Date	Expiration	Release	Page
05.2015	05.2017	1	1(5)

Release 1: Original Release (2012 vehicles)

DIFFUSER PIPE WRAP INSTALLATION Prevost vehicles

Figure 1

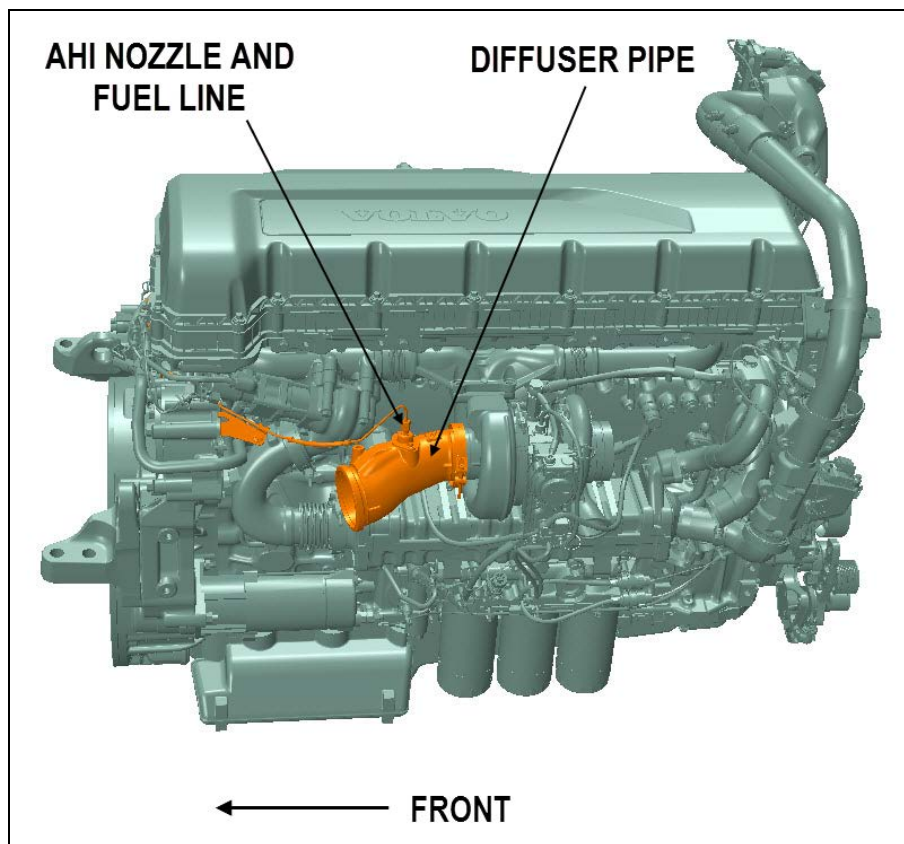
- 1) Remove the vehicle rear bench seat cushions and frame to access the engine access panel located underneath the seat.
- 2) Open the access panel and locate the diffuser pipe and AHI nozzle at the exit of the turbo compressor (Figure 1).

Figure 2

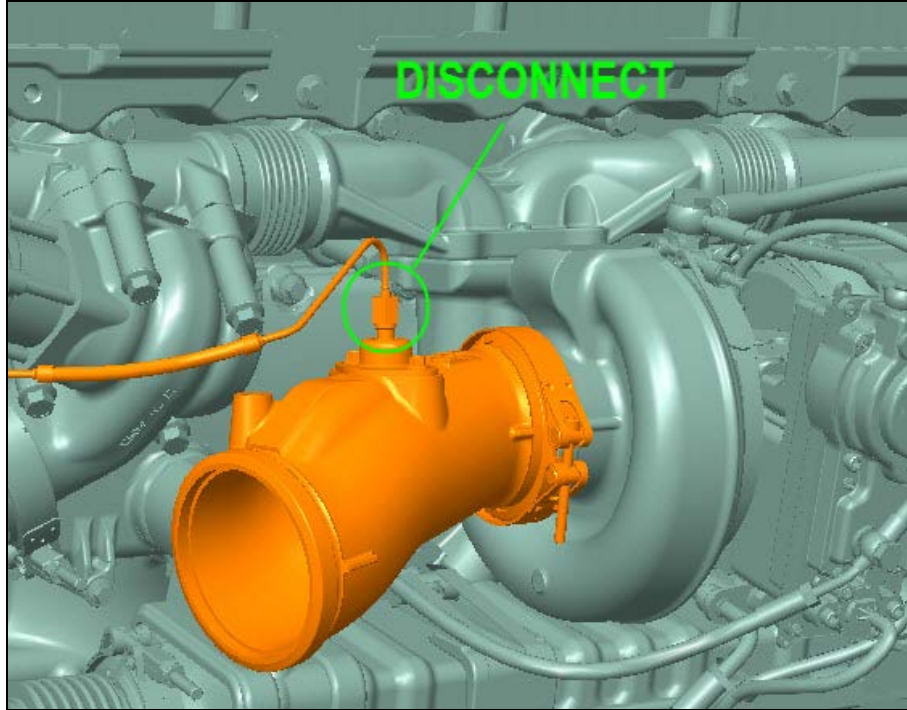
- 3) Disconnect the fuel line going to the AHI nozzle (Figure 2).

Figure 3

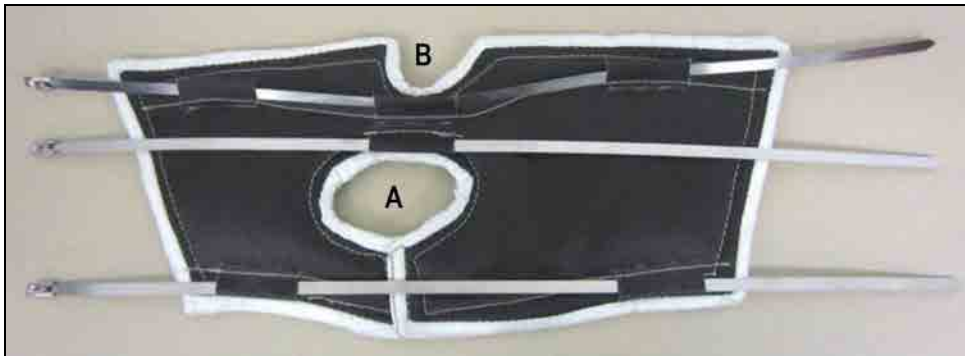
- 4) With the fuel line out of the way, install the #22595824 Insulating Wrap around the diffuser pipe with the nozzle sticking out of the wrap opening (A) as shown in Figure 3 and 4 below (the notch in the insulating Wrap (B) goes toward the front of the vehicle).

Figure 5

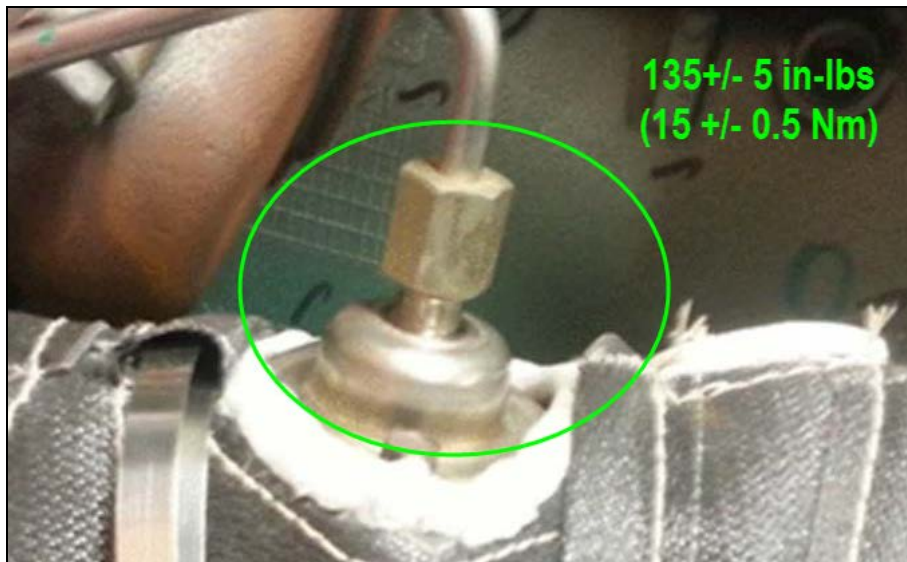
- 6) Reconnect the fuel line to the AHI nozzle (Figure 5) and torque the hexagonal fitting to 135 ± 5 in-lbs. (15 ± 0.5 Nm).
